1. Planning Board Meeting Materials 2026-01-05

AGENDA
York Planning Board Meeting
January 5, 2026
7:00 PM
York Public Library

TO: The York Planning Board
FROM: Brendan J. H. Summerville, Town Planner
DATE: 5 January 2026
RE: Sketch Plan Application Review – 60 Main Street
Map/Lot 0020-0001-A

TO: Planning Board
FROM: Brendan J. H. Summerville, Town Planner
DATE: 5 January 2026
RE: Sketch Plan Application Review – 985 & 995 US Route 1
Map 94 Lot 75A and Map 30A Lots 18 & 29

ROOF PLAN + ELEVATION
EXISTING/DEMOLITION
SCALE: 1/4" = 1'-0"

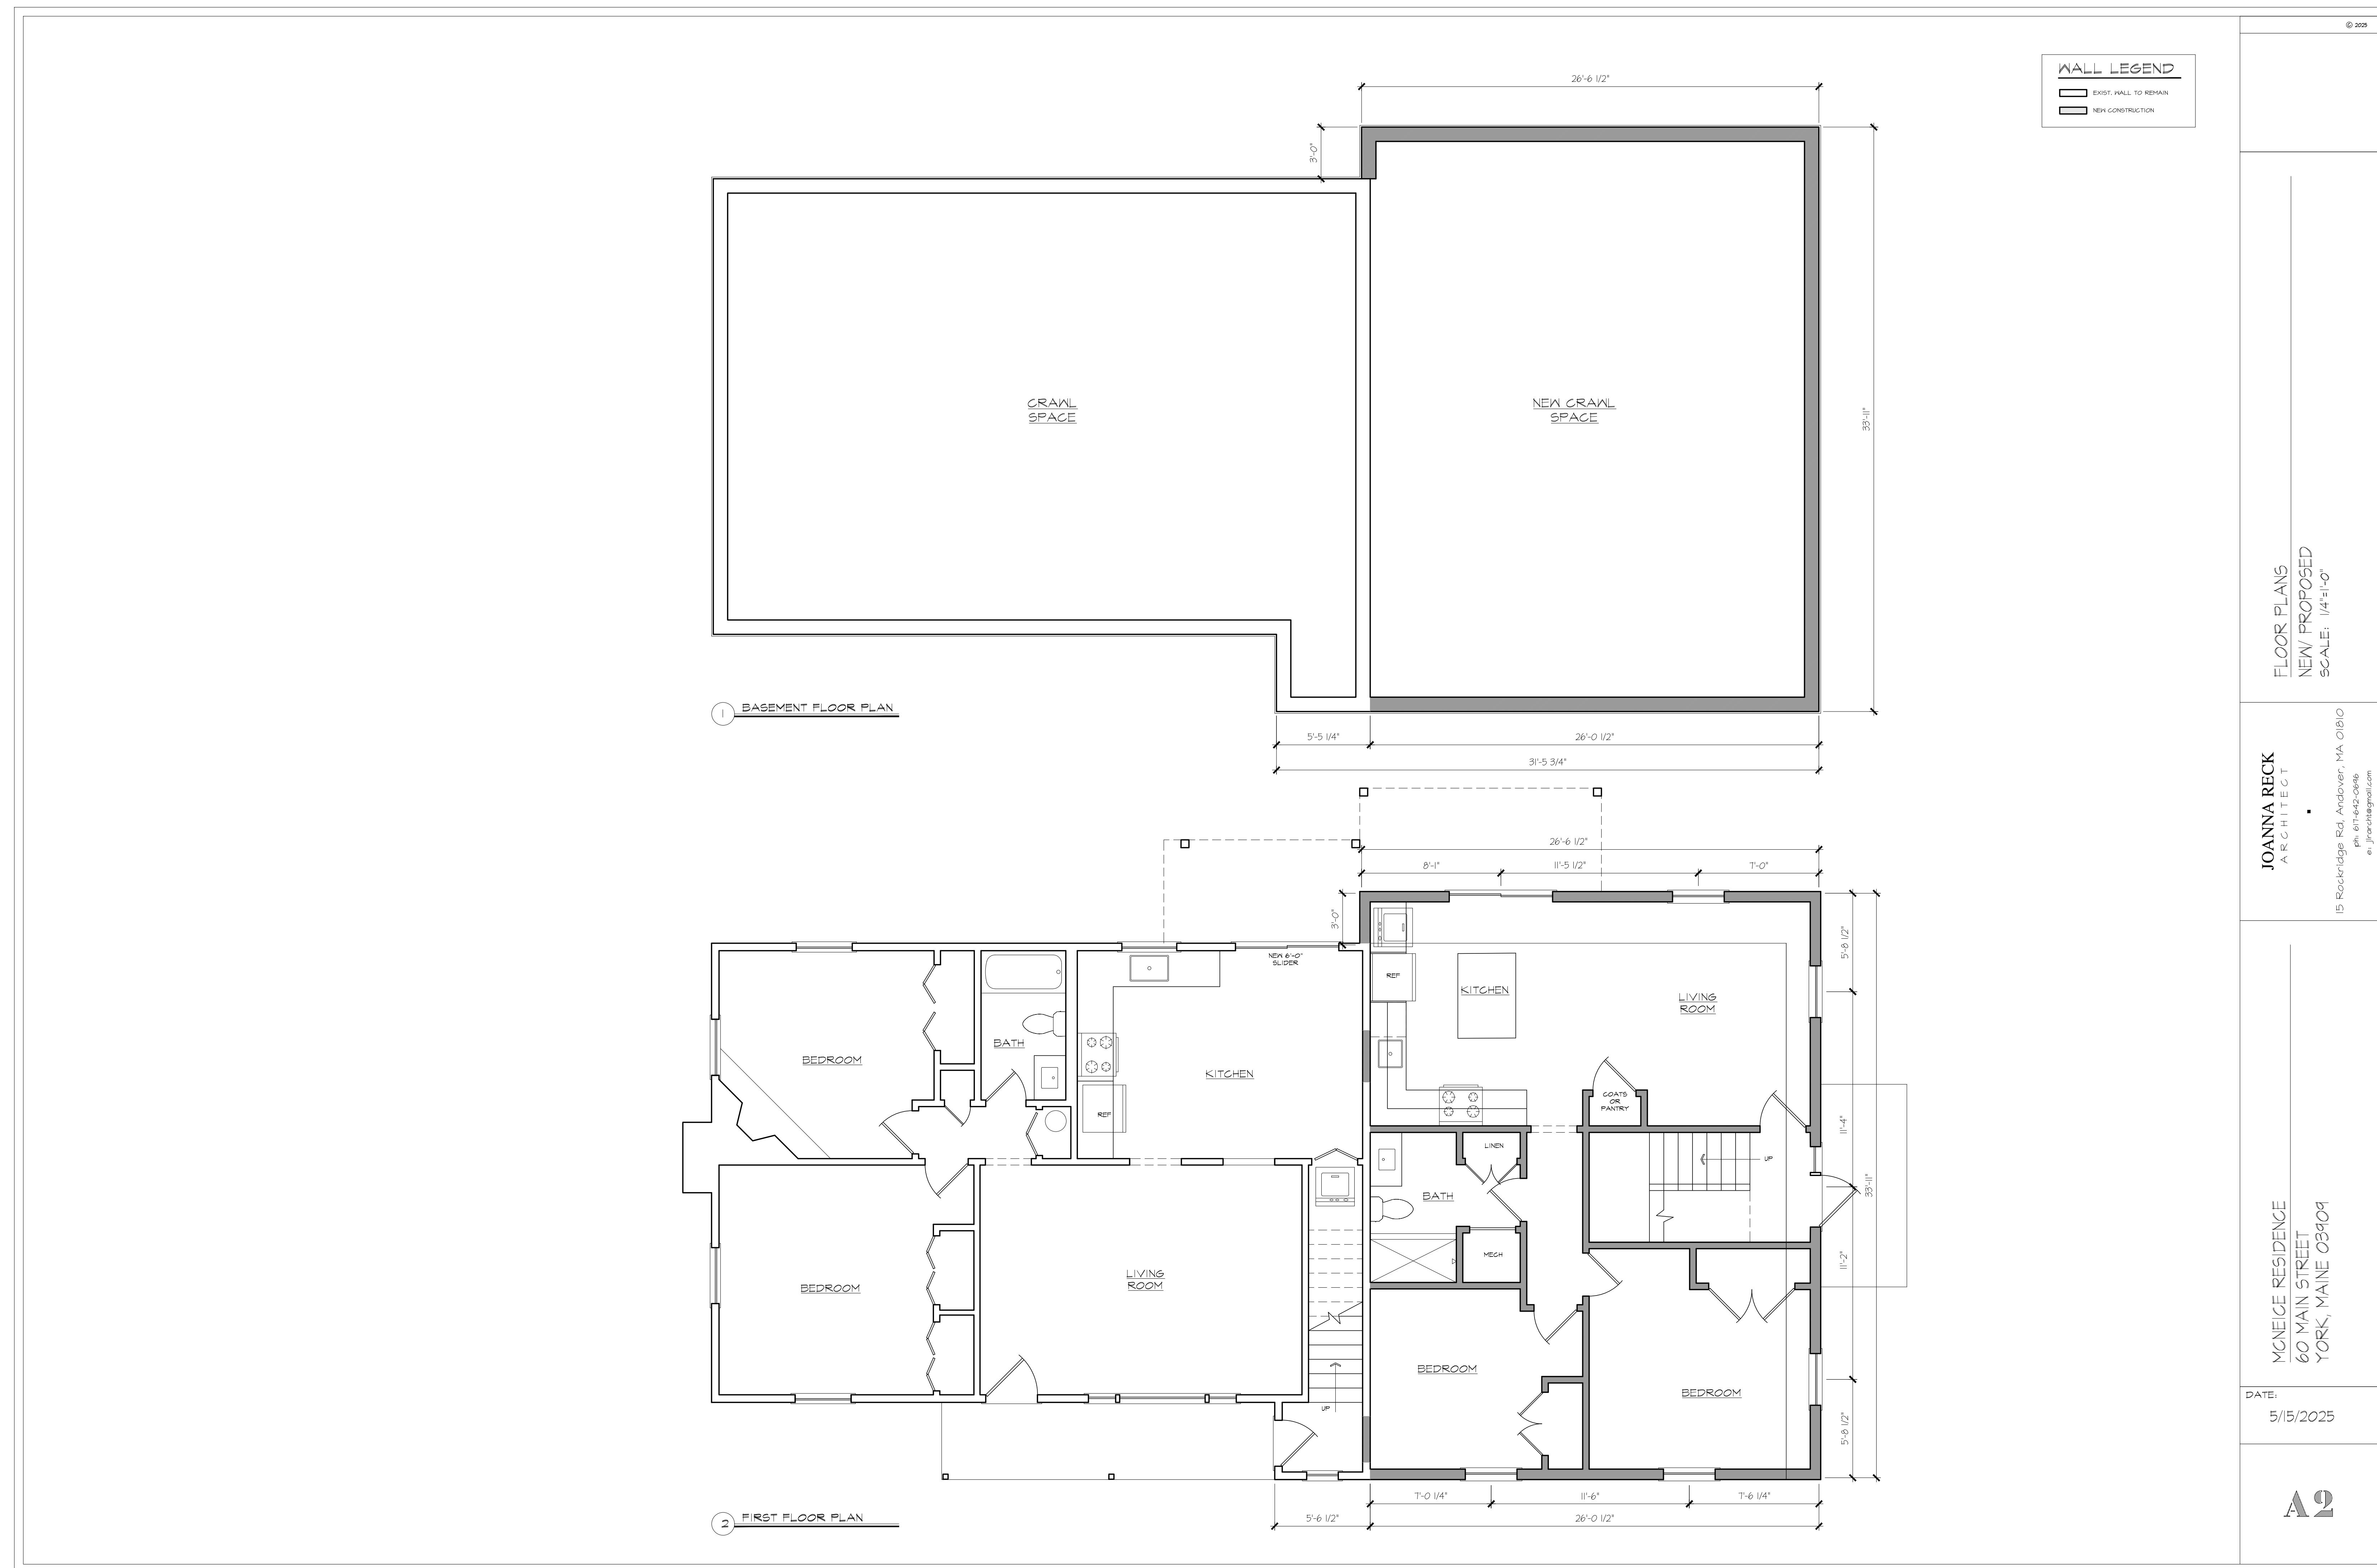
- A. Dimensional Regulations** – This property conforms to the CD-4 dimensional regulations, as presented in §10-I.4.2.1 with one exception. The CD-4 zone has a maximum front setback of 20ft, and the existing conditions plan depict a distance of 32.1ft from the road. Per §10-I.2.3.1 *General*, this development is not-exempt from these dimensional standards, even as a redevelopment of the existing structure. Were the front façade moved or extended to be within 20ft of the front property line, then this would be rendered moot.
